ADDENDUM NO. 1
05/01/2024

PROJECT: CITY OF IDALOU
WATER TREATMENT IMPROVEMENTS

BID DATE: MAY 8, 2024

CITY OF IDALOU
WATER SYSTEM IMPROVEMENTS – CONTRACT 1 – WATER TREATMENT IMPROVEMENTS
BASE BID - ADDENDUM #1

WTP BUILDING SECTION 2

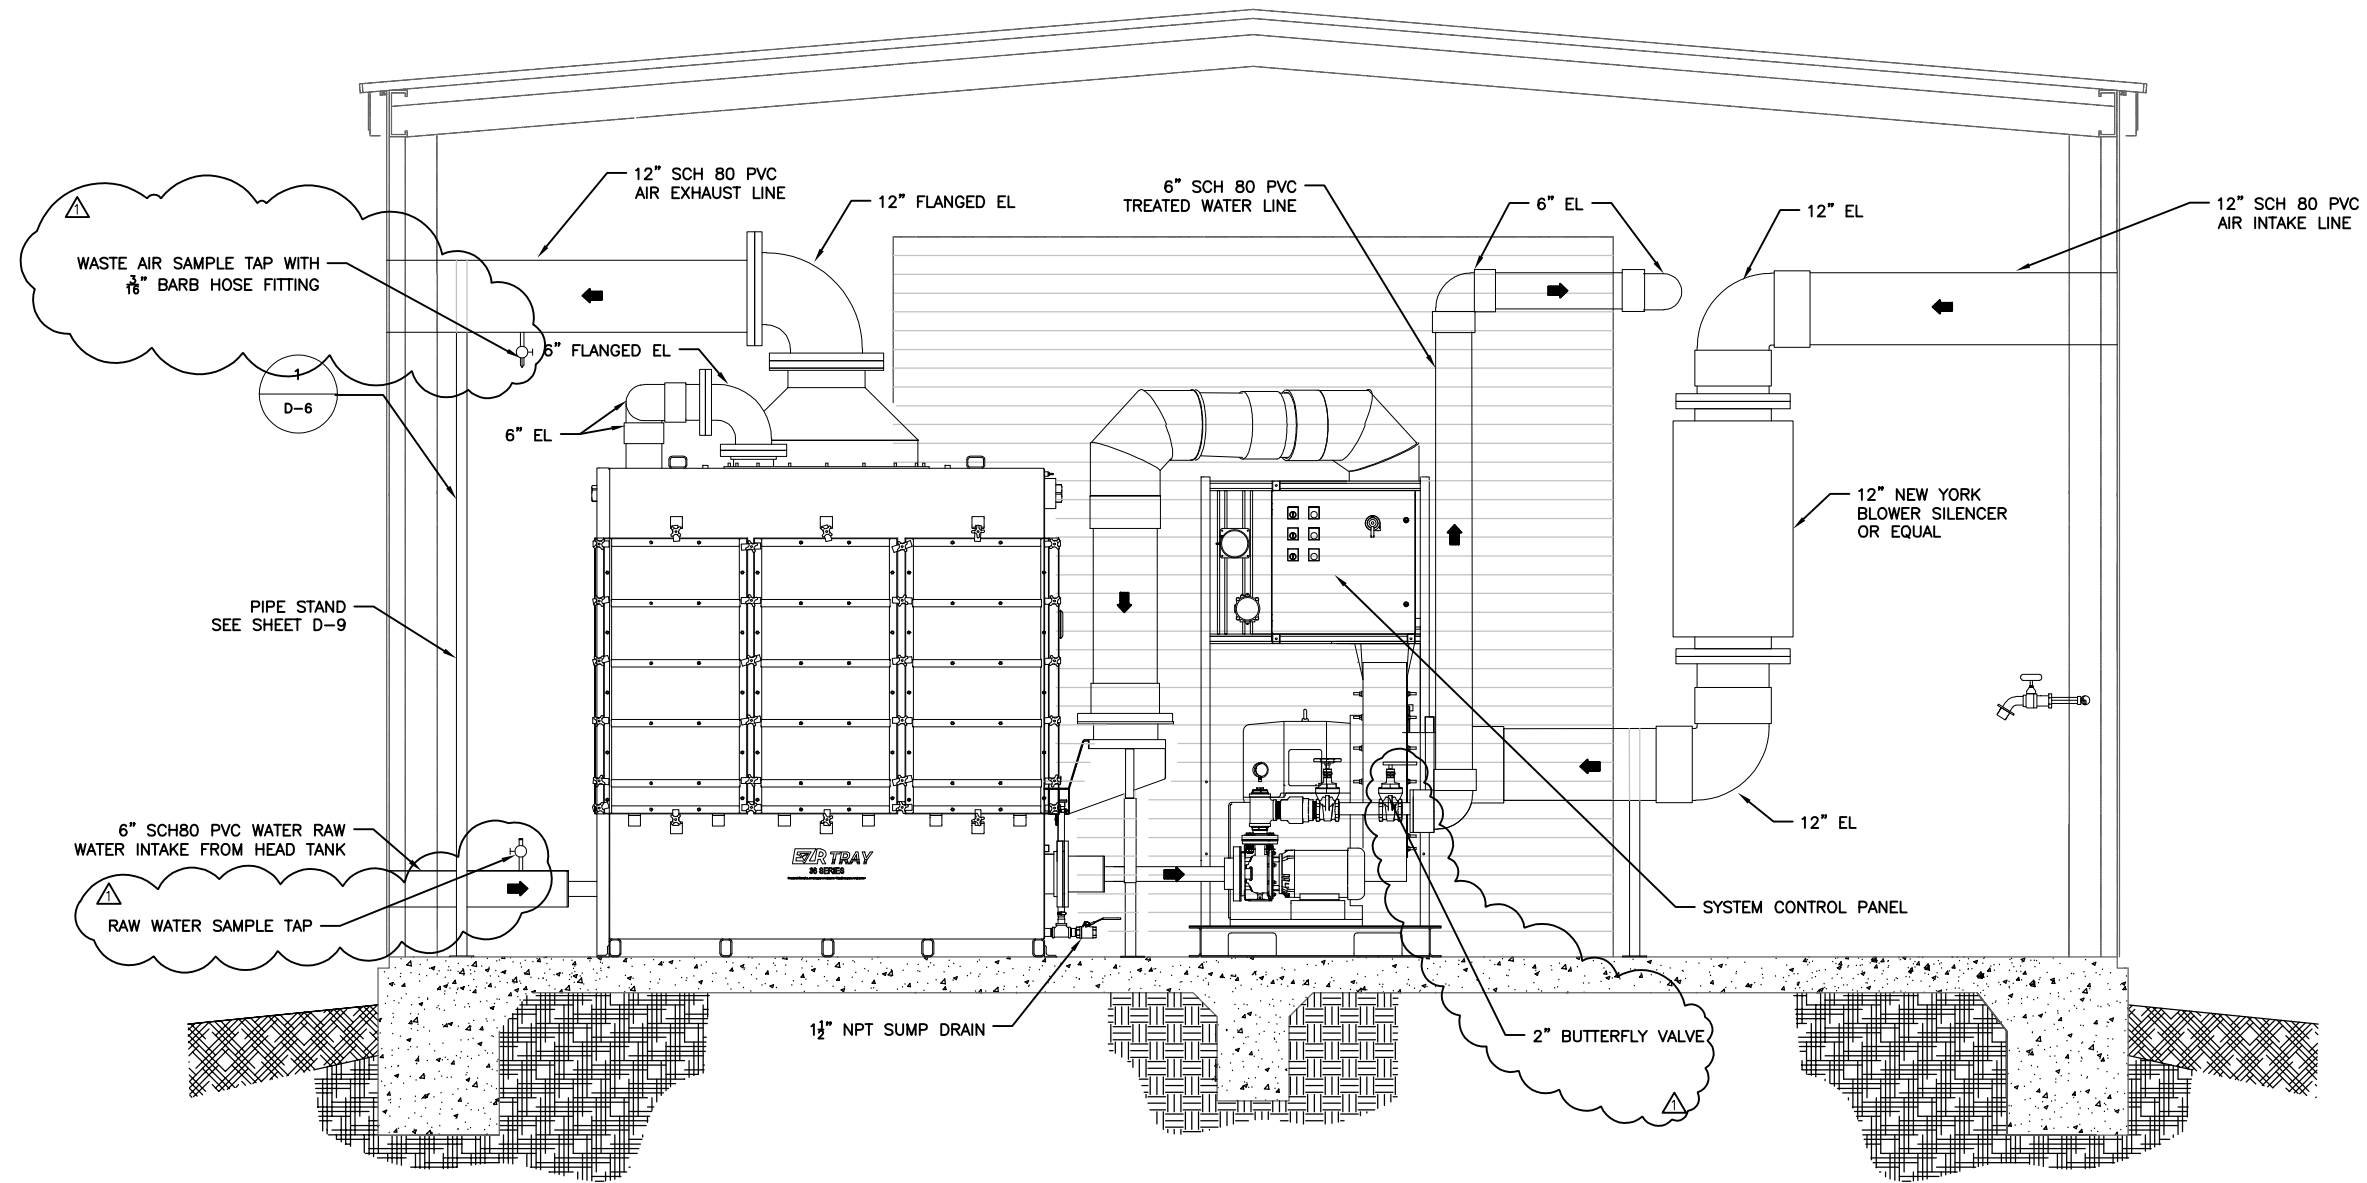
- a) Sheet C-11 – This sheet has been revised to clarify the drive area material.
- b) Sheet D-3 – This sheet has been revised to clarify fencing at tank and VGAC units.
- c) Sheet D-5 – This sheet has been revised to add air and water sampling valves/taps as well as a 2” butterfly valve off the transfer pump discharge.
- d) Sheet D-7 – This sheet has been revised to add a feed pump flow meter (6” McCrometer with ProComm readout or equal).
- e) Sheet S-2 – This sheet has been revised to add a detail for the brick wainscot siding.
- f) Sheet S-3 – This sheet has been revised to clarify the crushed base aggregate road section.
- g) Sheets E-1 through E-8 have been revised and include miscellaneous electrical changes.
